CITY OF ALBUQUERQUE

RE: **Beltran Townhomes**
2125 St. Cyr SE
Grading Plan Stamp Date: 12/21/19
Hydrology File: K15D105

Based on the submittal received on 1/3/20, this project cannot be approved until the following information, per the DPM Ch. 22.7, *Grading Plan Checklist* is provided:

GRADING AND DRAINAGE PLAN

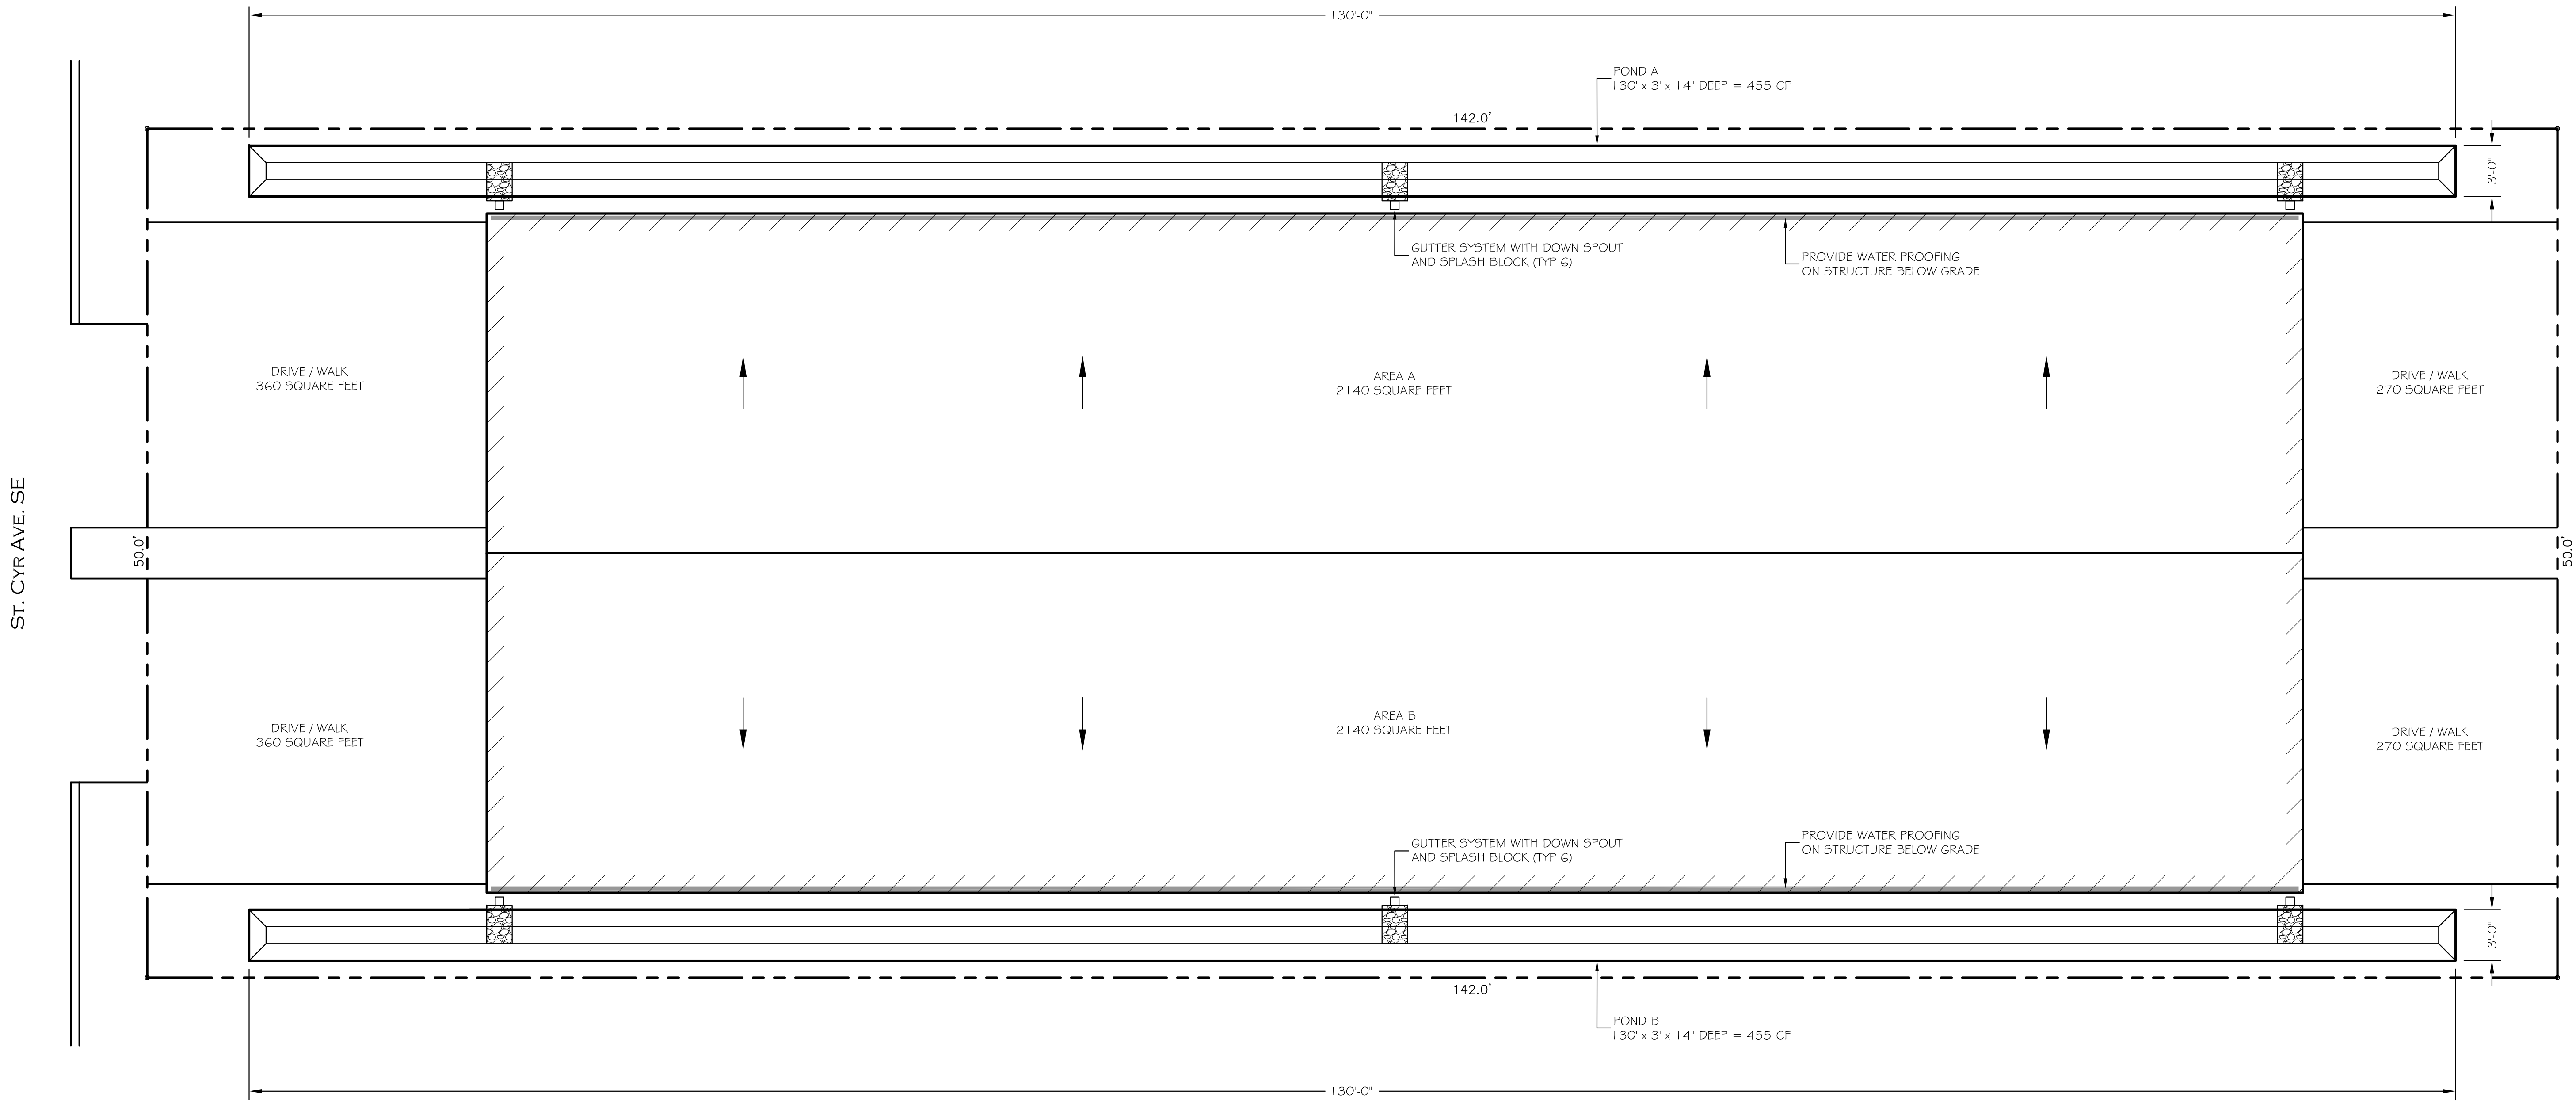
General Information:

- Legend - see D.P.M. Manual, Volume 2, Tables 27.3a - 27.3d for recommended standard symbols
- Vicinity Map
- Benchmark - location, description and elevation
- Flood Insurance Rate Map (FIRM)
- Legal Description

Existing Conditions:

- Existing Contours
- Spot elevations adequately showing conditions on-site.
- Contours and spot elevations extending a minimum of 25' beyond property line.
- Identification of all existing structures located on-site or on adjacent property extending a minimum of 25' beyond property line with particular attention to retaining and garden walls.
- Identification of all existing drainage facilities located on-site or on adjacent property.
- Pertinent elevation(s) of structures and facilities defined above with NAVD 88 designation.
- Indication of all existing easements and rights-of-way on or adjacent to the site with dimensions and purpose shown.
- Existing City top of curb and flow line elevations with NAVD 88 designation.
- Contributing Area - delineation of off-site contributing watersheds and/or drainage basins.

Proposed Conditions:

- Proposed Contours and Spot elevations
- Internal contributory drainage areas, including roof areas, outlined on plan.
- Flow lines defined by arrows and spot elevations with NAVD 88 designation.

- Pond(s) 100 year water surface elevation outlined and indicated on plan.
- Finish building floor elevations.
- Elevations along property lines including relationship to adjacent top of curb.

- Details of ponds, inverts, rundowns, curb cuts, water blocks, emergency spillways, retaining walls, pond outlets, safety fences, slopes, and all other significant drainage structures with contours, cross-sections and spot elevations. All cross-sections must be drawn to a standard engineering scale and adequately dimensioned.

- Proposed contours superimposed over existing contours adequately demonstrating changes in grade especially at the property line
- Identification of any required offsite grading

- Specifications for the proposed grading and/or soil compaction

The plan will also need to demonstrate compliance with the following relevant portions of City's Flood Control and Drainage Ordinance:

- Provide management onsite for the Stormwater Quality Volume (SWQV) in accordance with the new drainage ordinance, § 14-5-2-6 (H) enacted 10/2/18 (Council Bill C/S O-18-2). To calculate the required volume to be captured, multiply the impervious area (SF) by 0.34 inches for the 90th percentile storm.
- The site must demonstrate adequate downstream capacity per § 14-5-2-12(G) of the Albuquerque Code of Ordinances.
